Docket Item # 1
BAR CASE # 2015-0394

BAR Meeting
January 20, 2016

ISSUE: Alterations

LOCATION: 101 North Union Street

SHEET TITLE
ELEVATIONS

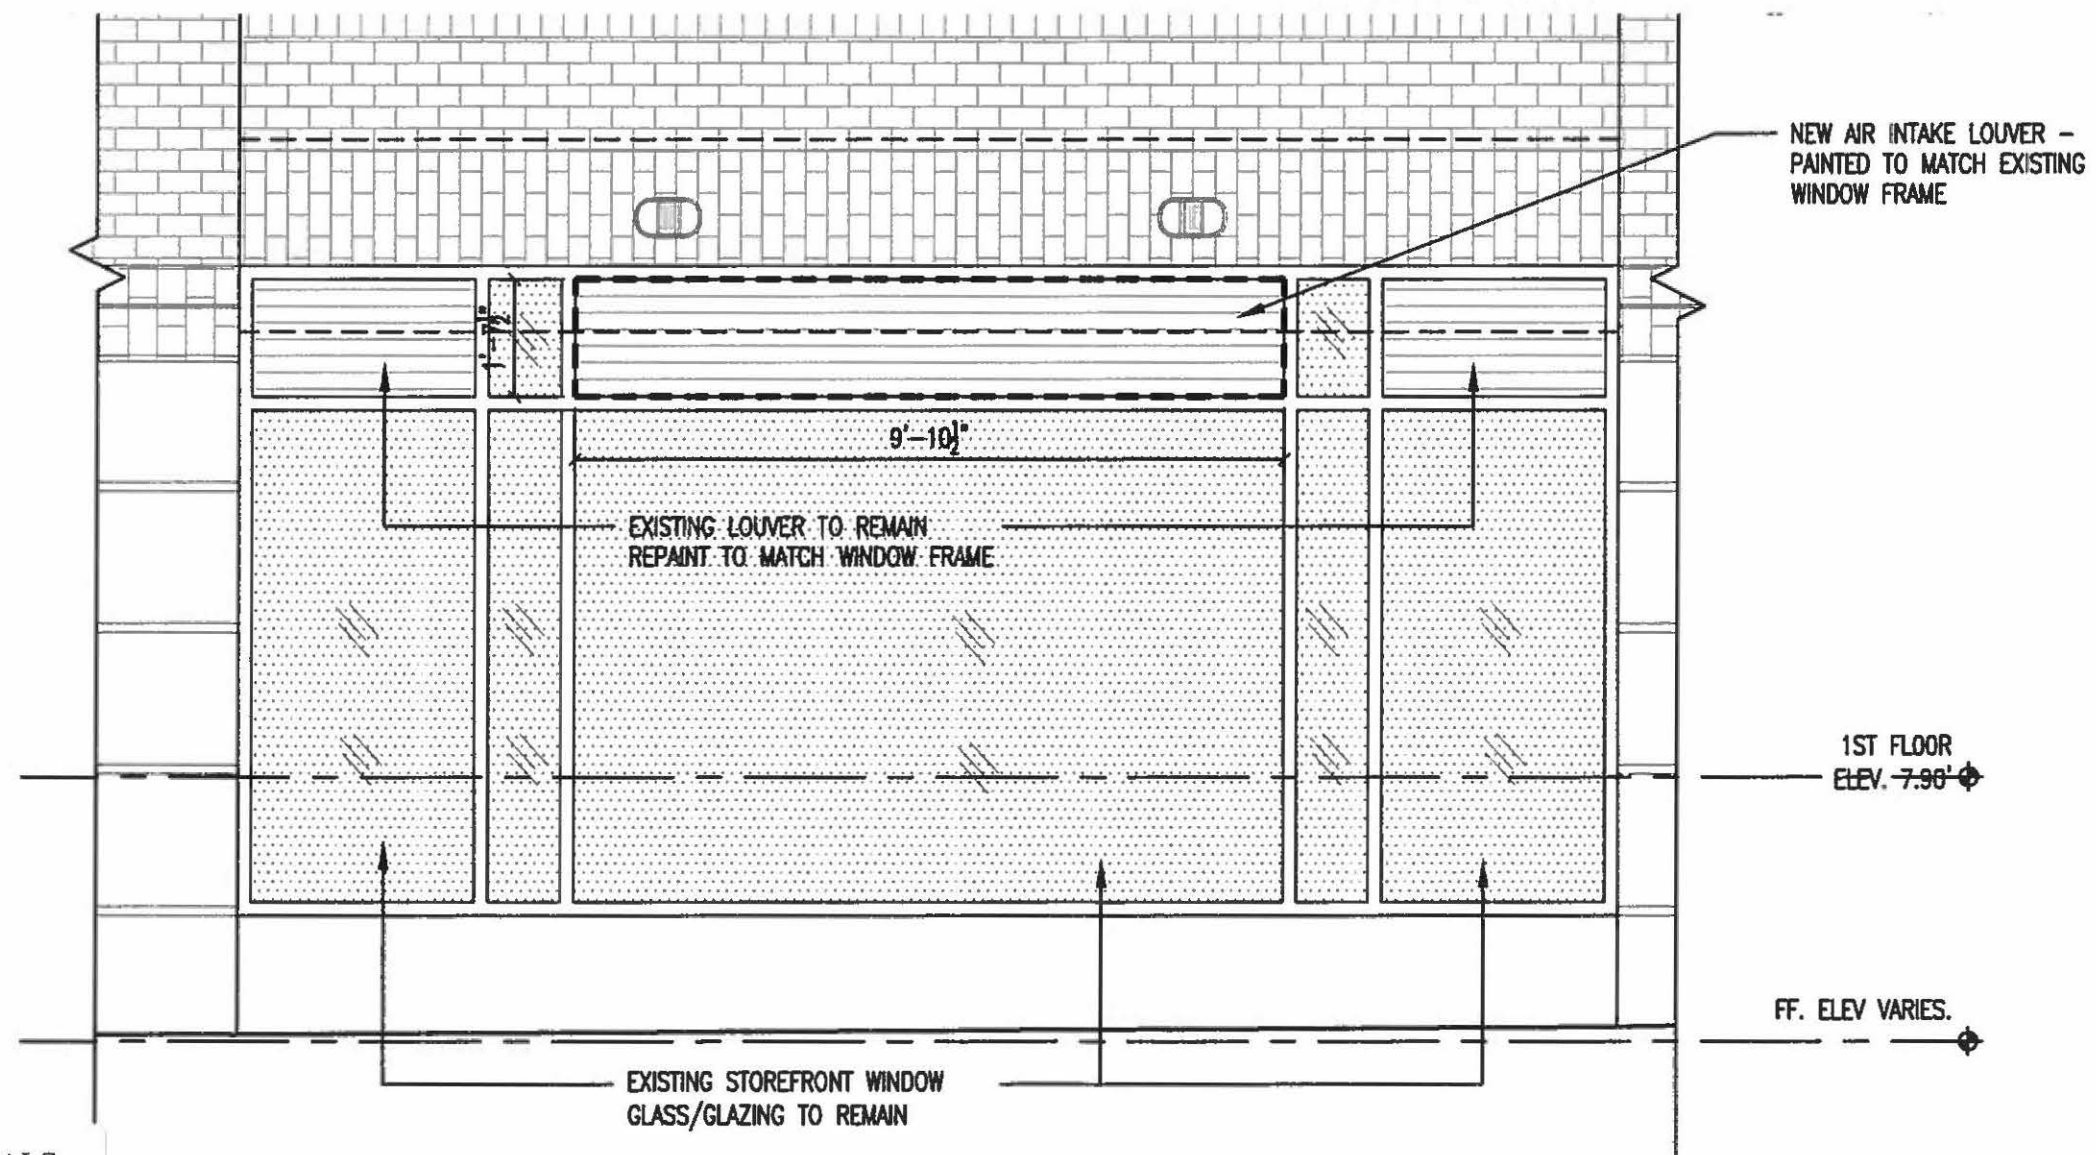
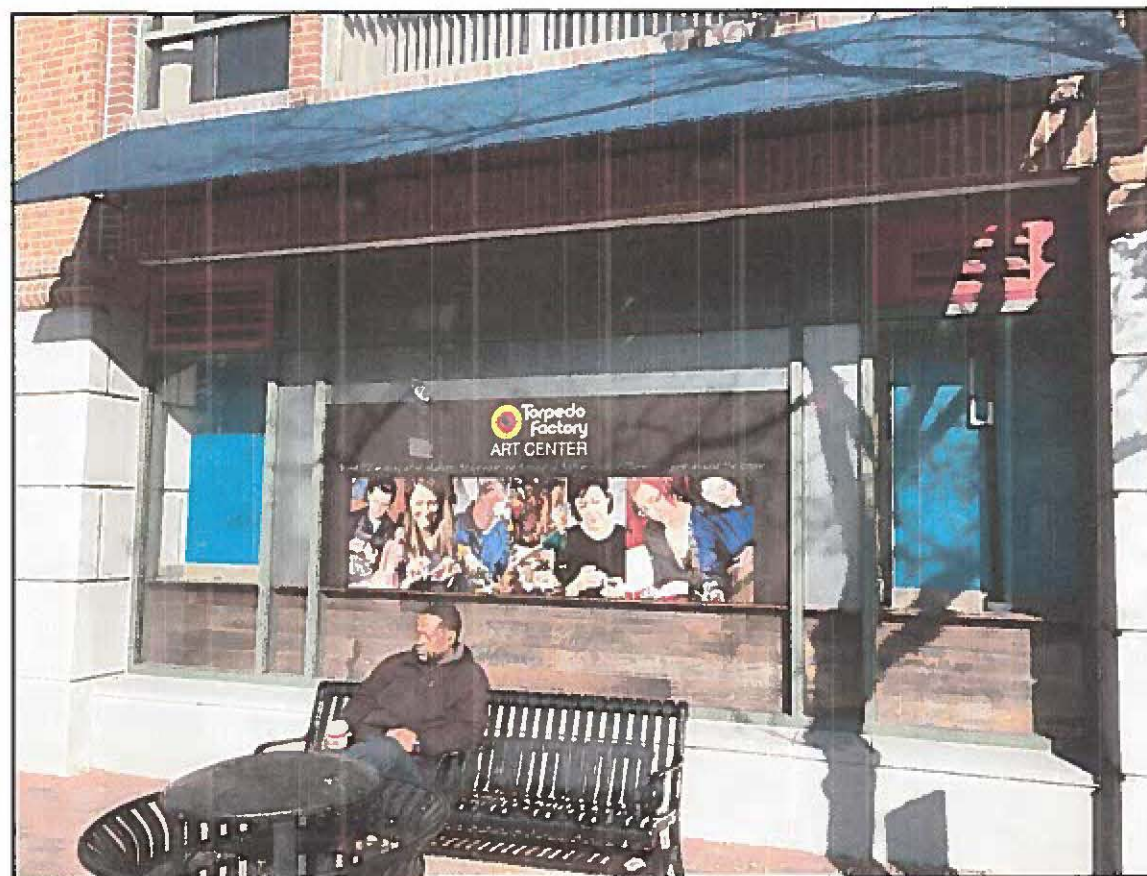
air vents and is most conveniently located near the mechanical room. Staff finds the proposed vent, while seemingly large at 16 square feet, to be discreetly located due to its position beneath an awning and within an existing transom of the storefront window. It is flanked on either side by existing air vents. Additionally, it is proposed to be painted the same color as the window frame, further obscuring this necessary and functional element.

Staff supports the application, as submitted.

PHOTO-RENDERINGS

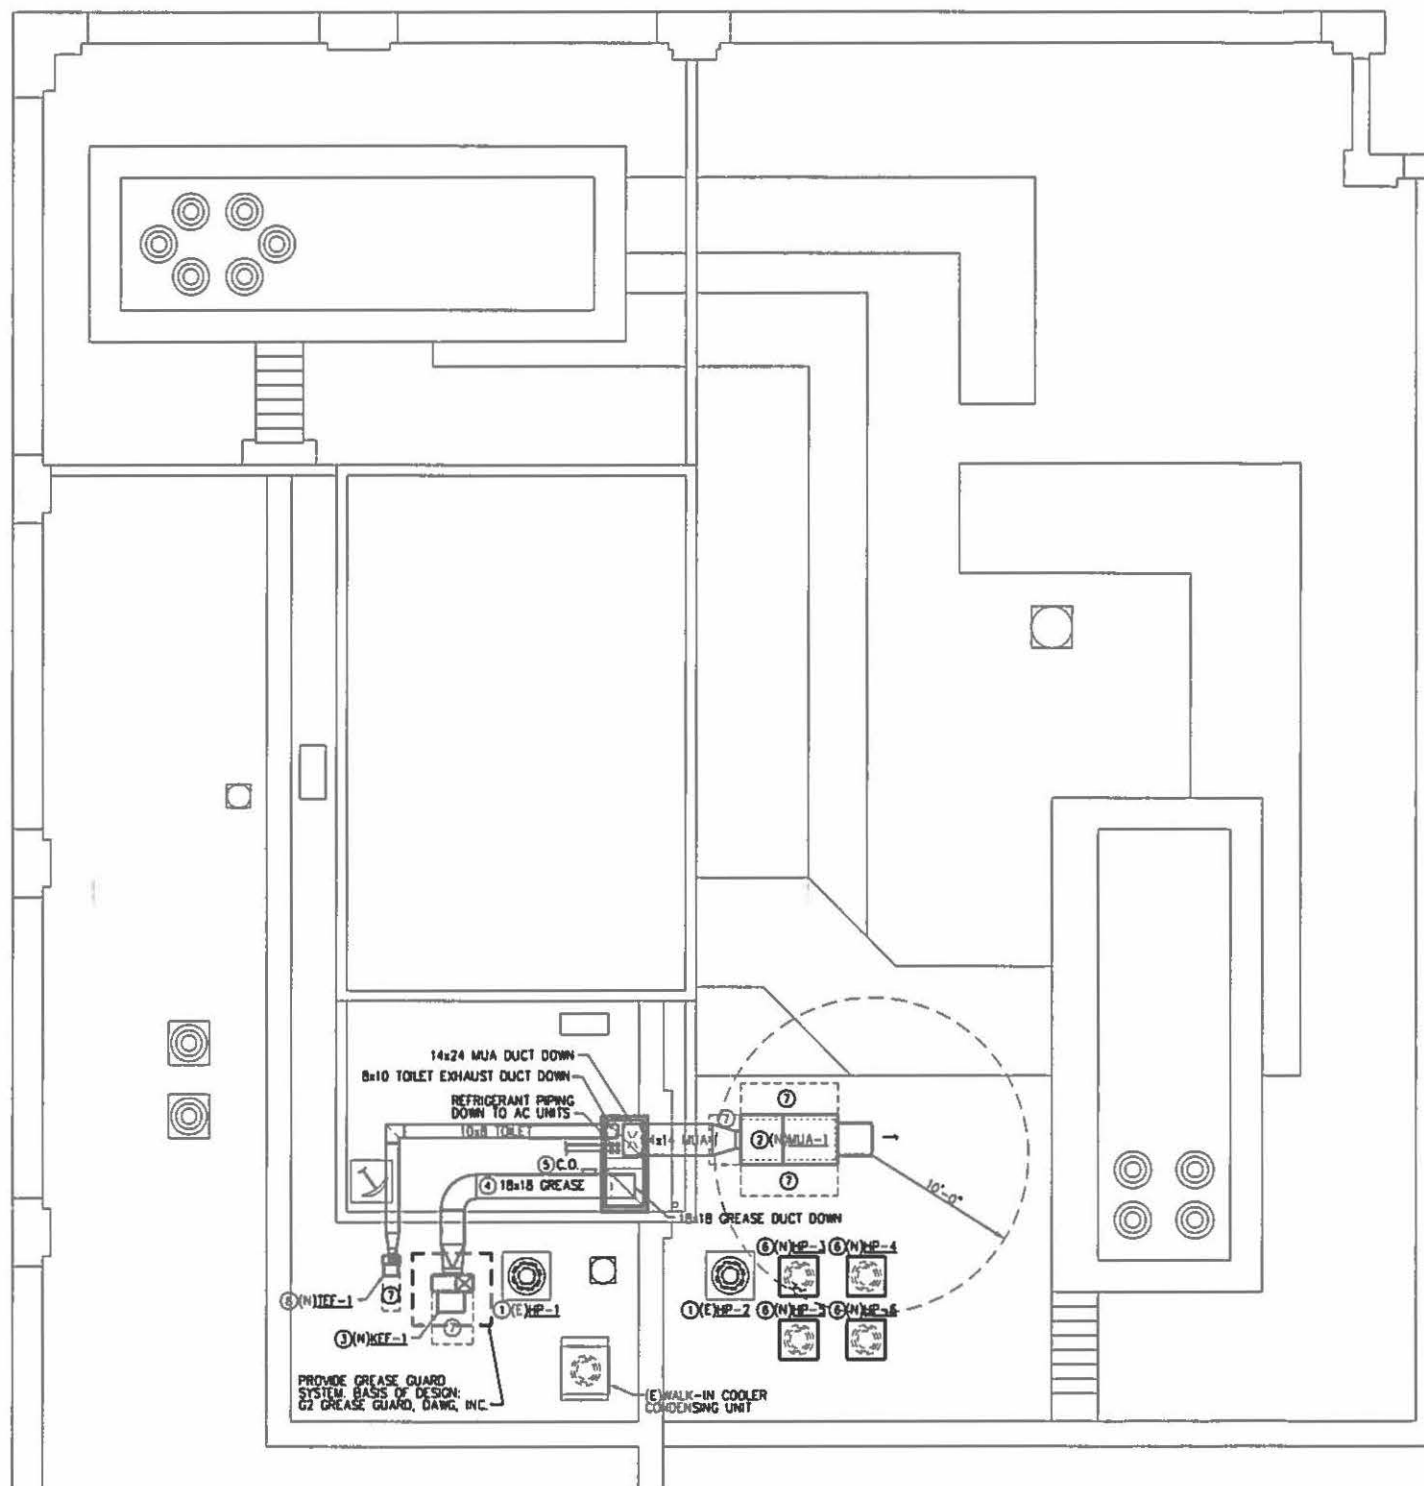
The applicant is requesting replacement of an existing spandrel glass transom over a storefront window with a metal louvered supply air vent in the transom of the existing storefront window system on the King Street elevation, necessitated by an expansion of the Waterfront Market restaurant. The proposed vent area measures approximately 16 square feet. The vent will be painted to match the existing window frame.
